PLANNING, ZONING, & BUILDING DEPARTMENT
PZ&B Staff Combination Memorandum: Town Council and Landmarks Preservation Commission

SUBJECT: ZON-23-089 (COA-23-031) 223 COLONIAL LN (COMBO)

MEETING: OCTOBER 18, 2023 LPC
NOVEMBER 15, 2023 TC

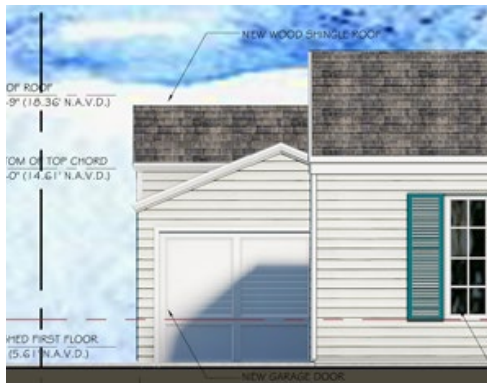
As it pertains to Variance 1, a variance for a side yard setback of 5' in lieu of the 12.5' required for an addition to an enclosed accessory structure, the applicant is seeking to maintain and continue a nonconforming west side yard setback as part of the renovation and addition to the existing detached garage structure.

NORTH ELEVATION

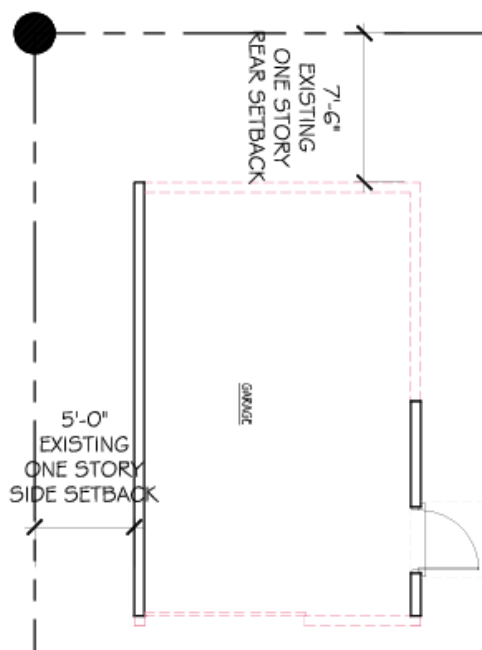
As it pertains to Variance 2, a variance for a rear yard setback of 5' in lieu of 7.5' existing and 10' required for an addition to an enclosed accessory structure, the applicant is proposing to encroach further into required rear yard setback as part of the garage renovation and addition.
